NOTICE TO BIDDERS "B"

BARRY J NIDORF SECURE YOUTH TRACK FACILITY
SECURITY AND KITCHEN UPGRADE PROJECT
SPECS. NO. 7878; C.P. NO. 8A018

This Notice to Bidders "B" clarifies certain portions of the Project Manual, drawings and forms, and answers questions received, all which are hereby made part of the contract documents.

A-1.01
(SKA-1)

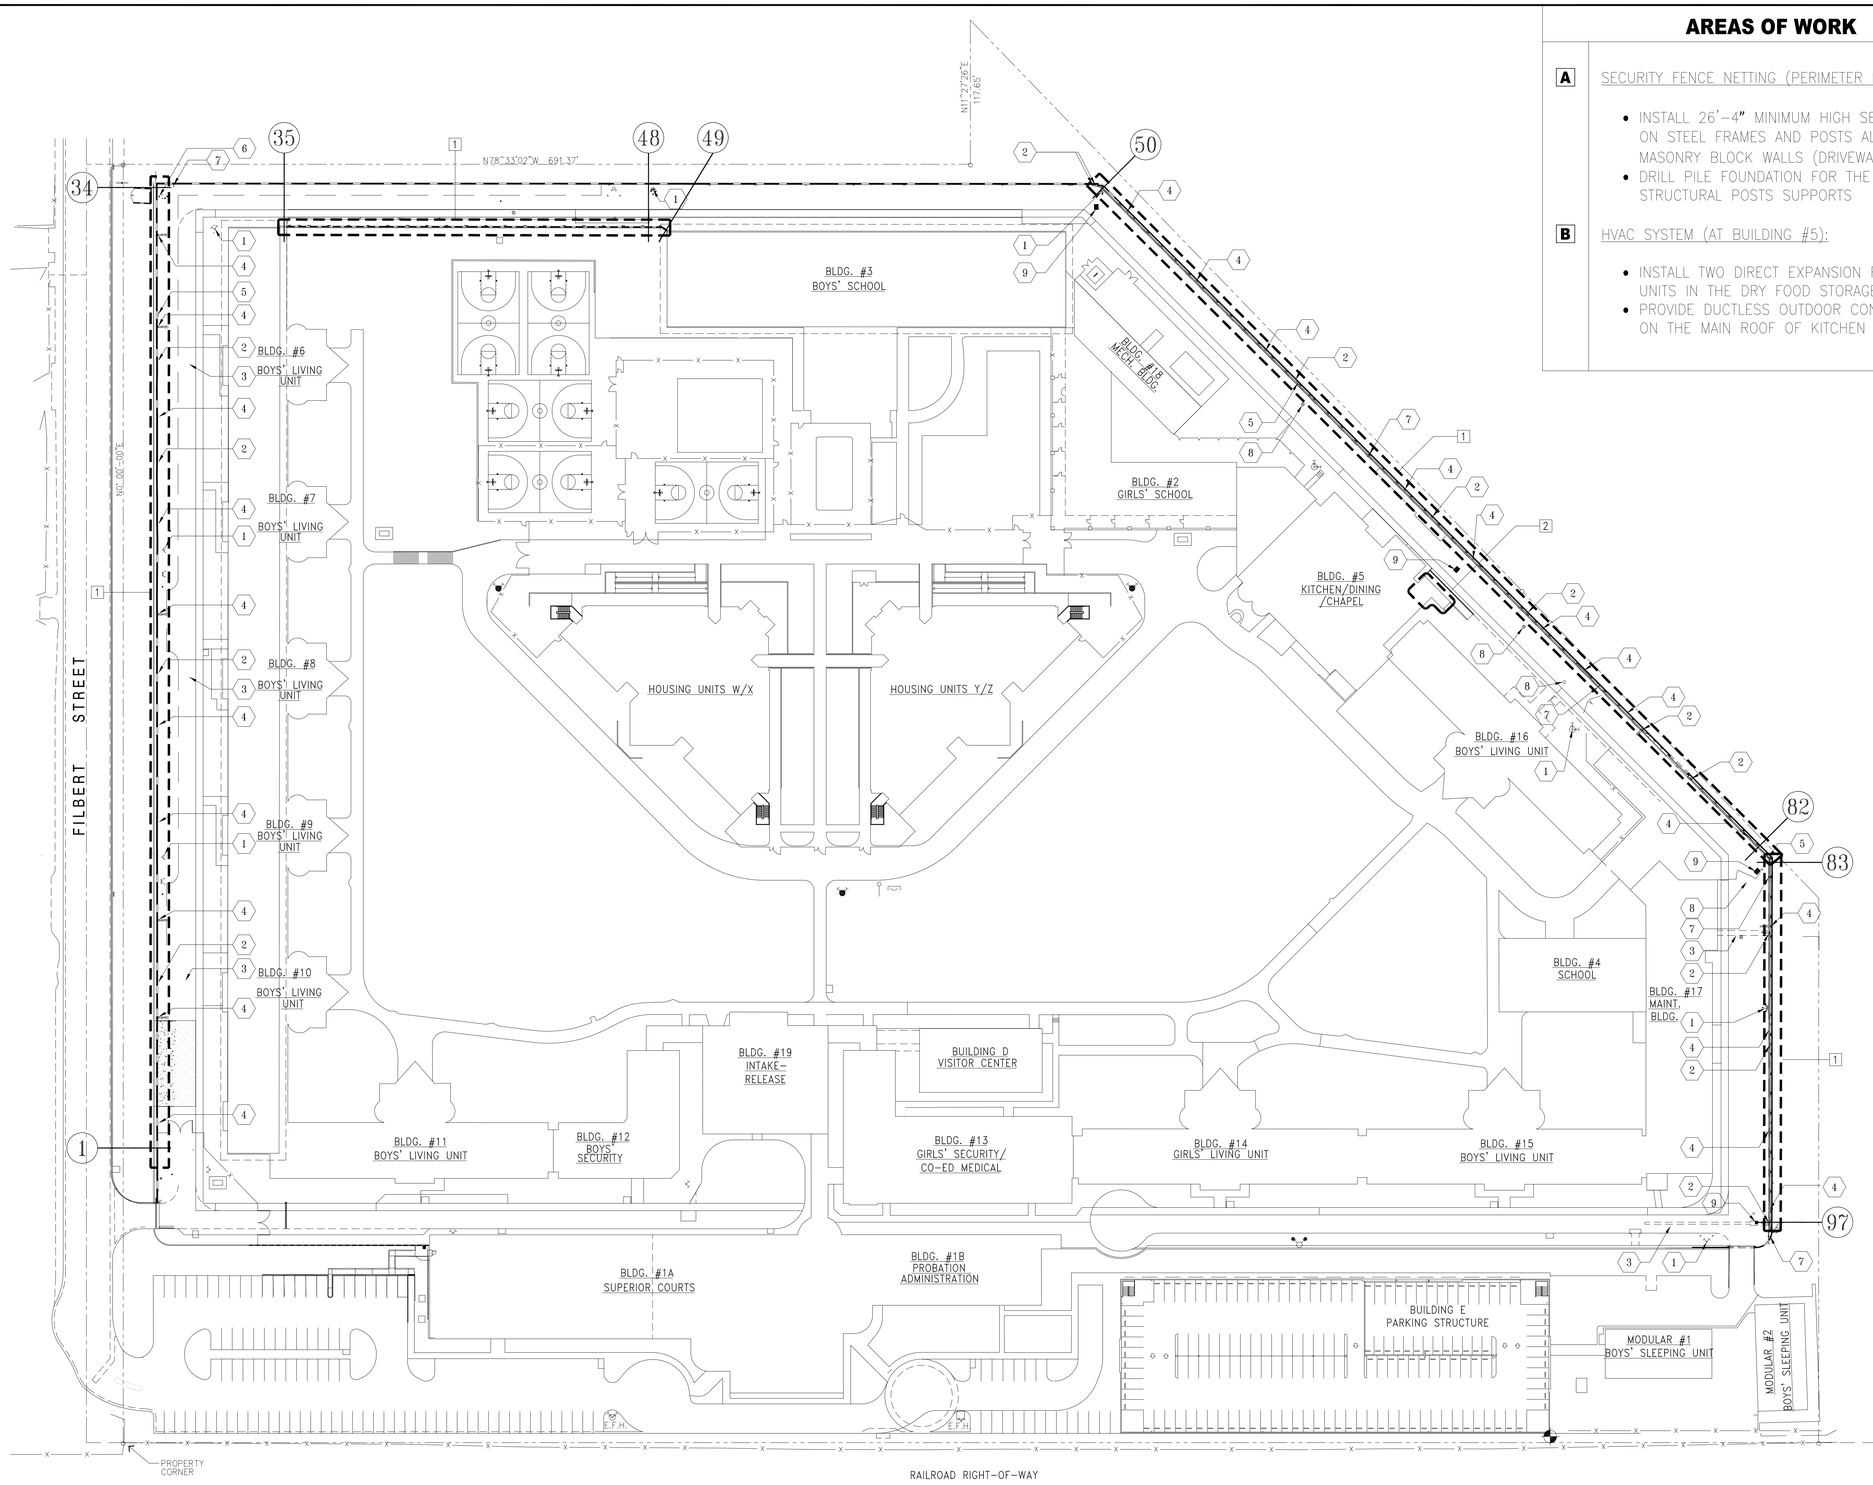
A. Refer to **Bid Drawing A-1.01**: Reissued as **SKA-1**.
   - Perimeter masonry walls are reflected on the drawing.

A-1.02
(SKA-3)

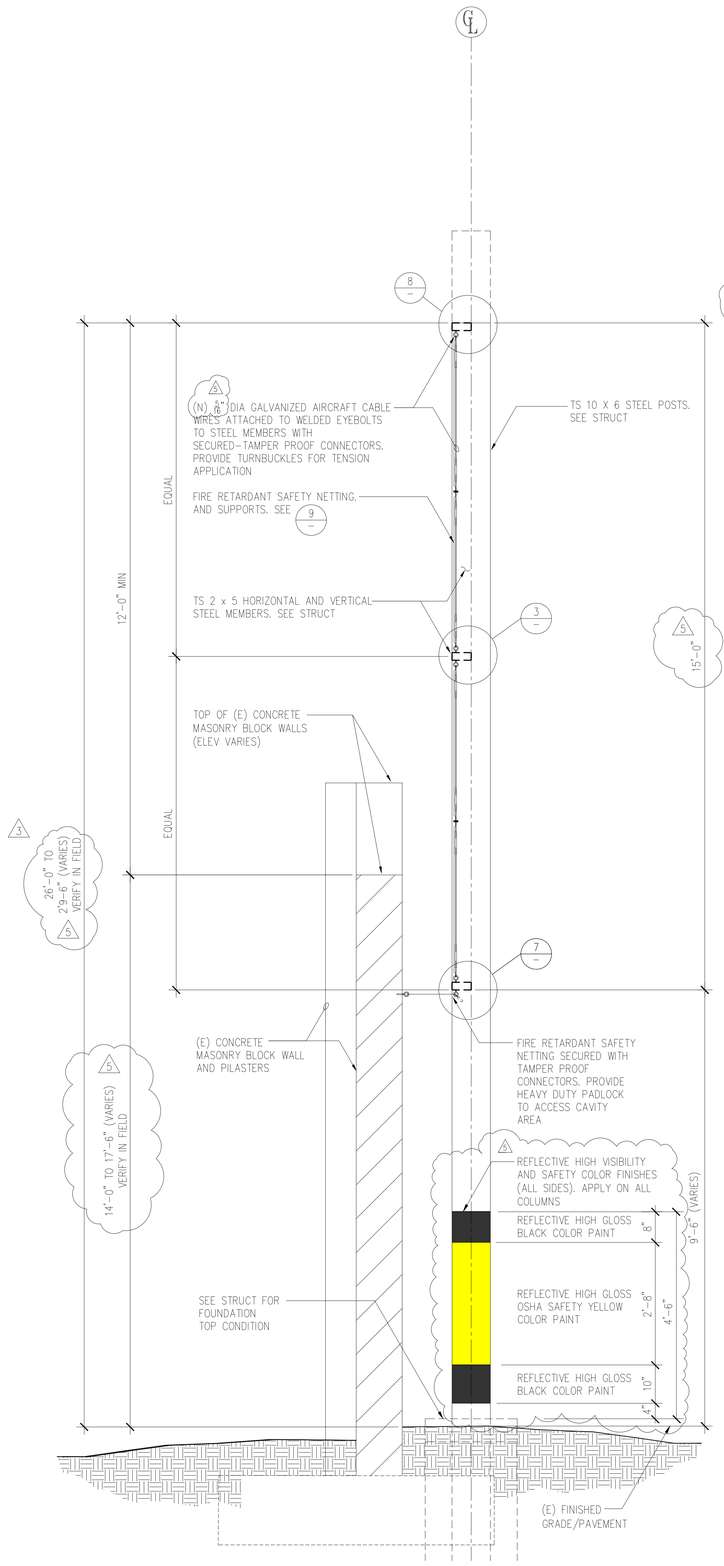
C. Refer to **Bid Drawing A-1.02**: Reissued as **SKA-3**.
   - Topographic survey is reflected on the drawing.

A-3.03 (SKA-4)

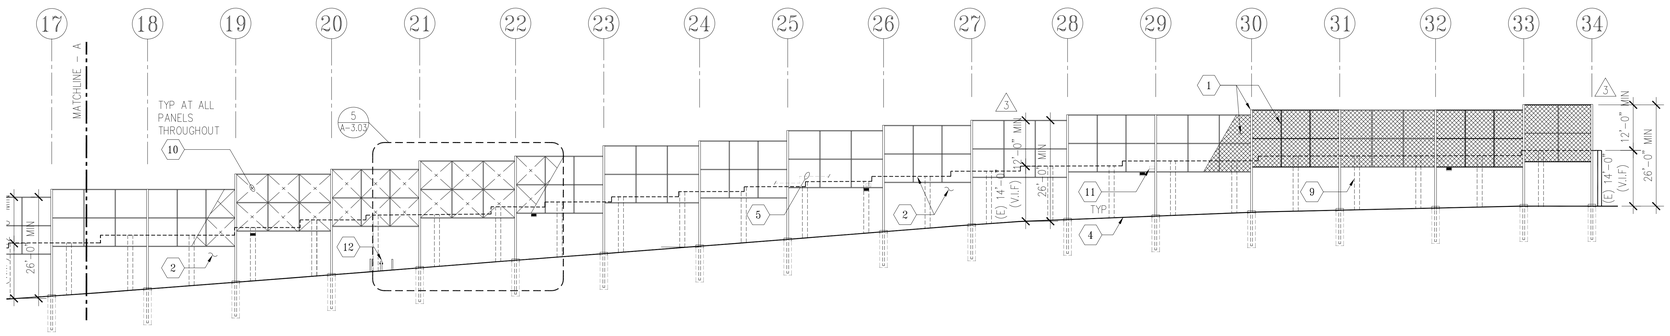
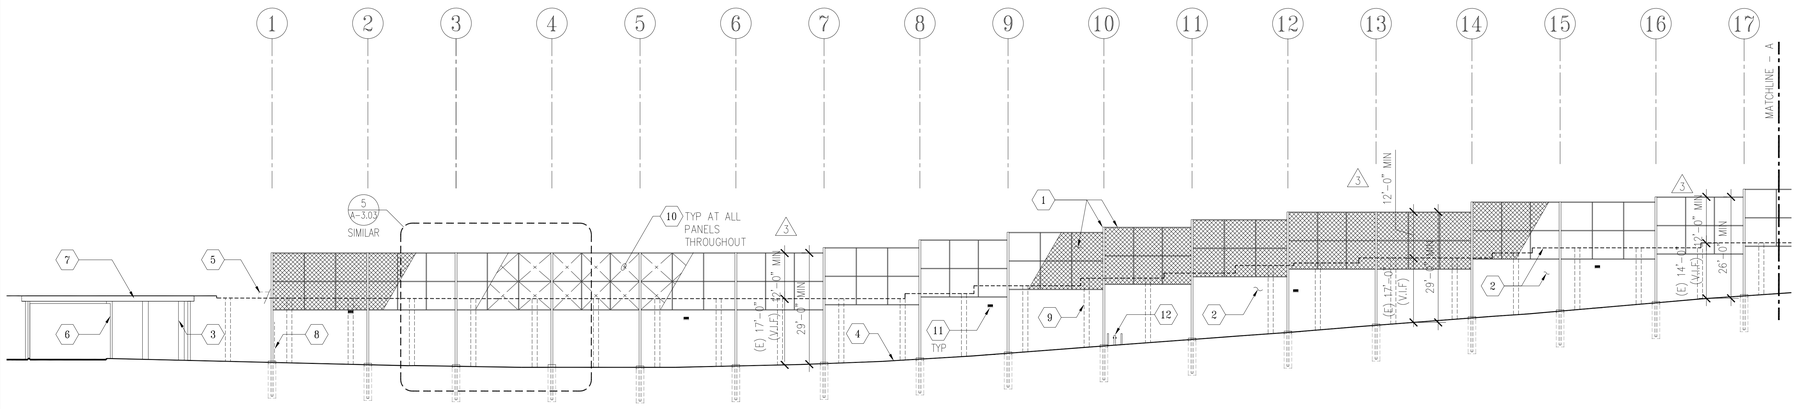
8. Question: Refer to the Nixalite Net for the fence shown on A-3.03. Prior to the net being installed, will the eye bolts and the cable holders be installed and welded prior to net installation? Typically, intermediate cable support/guides are16", not 4' apart. There is also mention of Edge Ropes which I highlighted on the detail page. Would you have any other information regarding this? I am contacting the vendor with some of these questions including the size of the cable (5/16"). If there is someone else that would have information regarding this project, please let me know.

F. Refer to **Bid Drawing A-3.03** w/ clouded revisions **Delta 5**: Issued as **SKA-4**:
- Clarification on Detail 2:
  - Turnbuckle and clamps notation.
- Revised Detail 5:
  - Reference callout spacings for eyebolts.
  - Added reflector and safety paint colors for all columns.
- Revised Detail 9:
  - Added reflector and safety paint colors for all columns.
  - Clarification on panels, steel columns and masonry wall heights.
- Revised Detail10:
  - Added reflector and safety paint colors for all columns.
  - Clarification on panels, steel columns and masonry wall heights.
- Revised Detail 5:
  - Reference callout spacings for eyebolts.
- Revised Detail 9:
  - Specifications for netting.
- Revised notes 3 & 8 under General Notes:
  - Eyebolt spacings and edge cable callouts.

- "Typically, intermediate cable support/guides are 16", not 4' apart."
    - Please see attached revised bid drawing A-3.03. Spacings have been revised to 24" max, equally spaced apart.

- "There is also mention of Edge Ropes which I highlighted on the detail page."
    - The edge rope as called out on the drawings is also referred to as stainless steel cables.

A-3.02
(SKA-5)

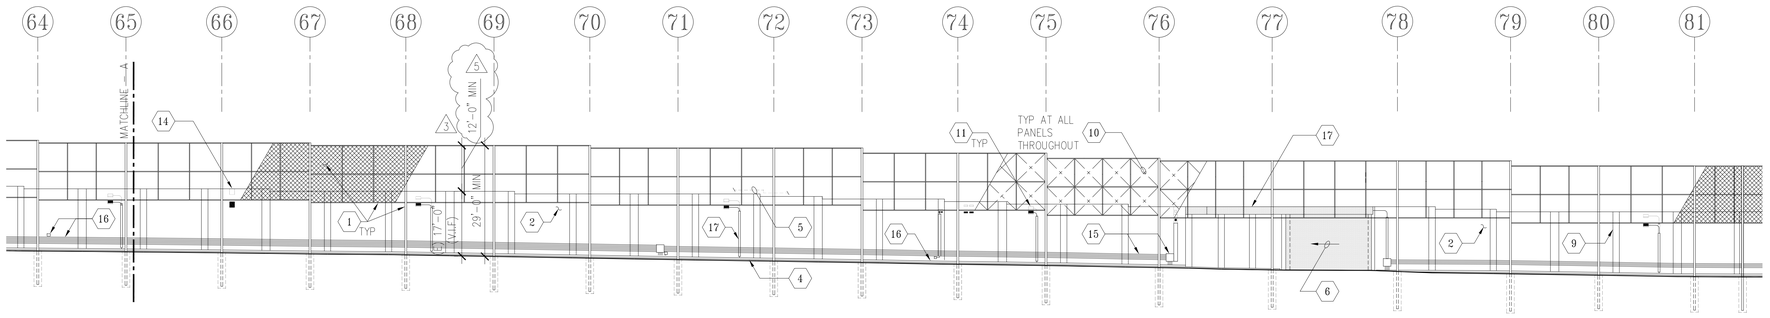
G. Refer to **Bid Drawing A-3.02** w/ clouded revisions **Delta 5**: Issued as **SKA-5**:
- Clarification on Detail 3: 12'-0" min reference callout for top of frame from existing masonry block walls.

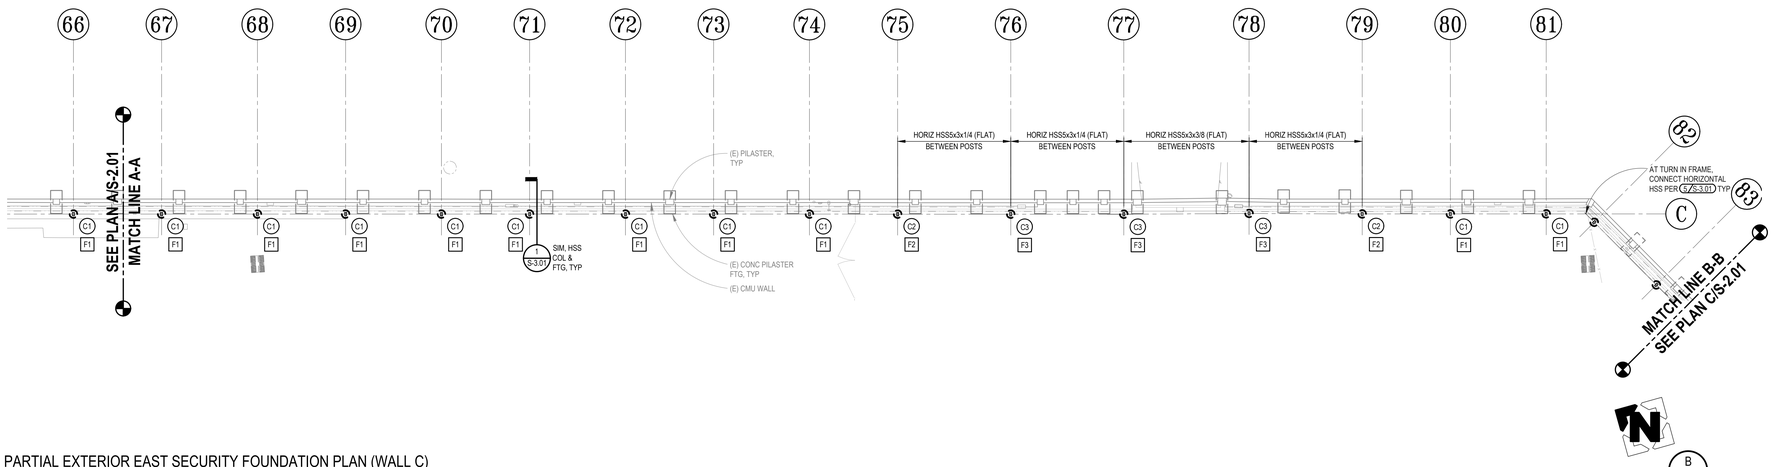
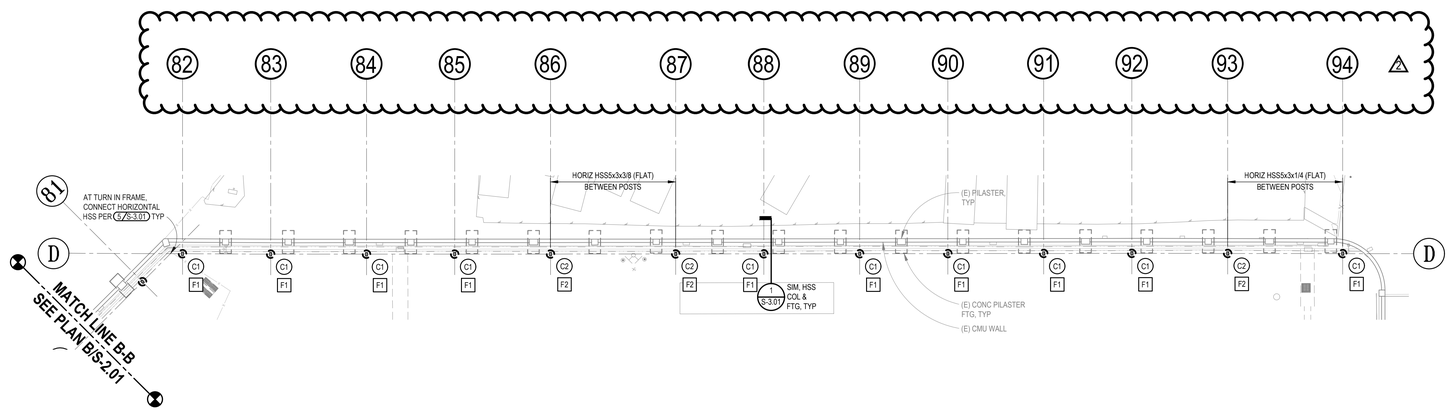
b. Architectural Drawings. For clarification, column grid callouts have been revised on detail C on S-2.01.

Answer: Architectural drawings will supersede in this discrepancy. Bid Drawing Detail C on S-2.01 is revised and reissued in this notice. Addendum 1.

B. Refer to **Bid Drawing S-2.01** w/ clouded revision **Delta 2**: Issued as **SKS-1:**
- For clarification, column grid callouts have been revised.

2
S-3.01

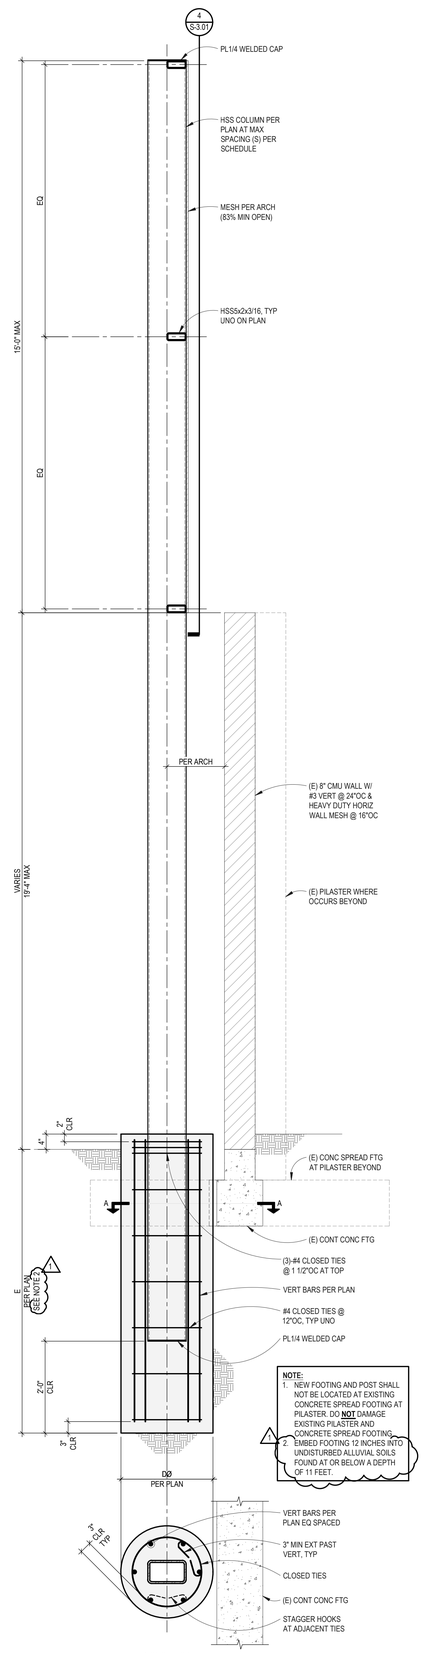
16. Question: There is discrepancy between Architectural 6/A-3.03 and Structural 4/S-3.01 regards to the distance between the Vertical 5x2x3/16. Architectural calls for equal space and structural calls for 5'0" On Center. Please confirm which drawings supersede.

C. Refer to **Bid Drawing S-3.01** w/ clouded revisions **Delta 2**: Issued as **SKS-2**:

- For clarification, Detail 3 (Not-reissued):
  - Make note that typical panel height is 15'-0". See **Bid Drawing A-3.03** Detail 10 Issued as **SKA-4**.
- For clarification, Detail 4:
  See architectural elevation drawings for number of equally spaced panels in between column spacings.
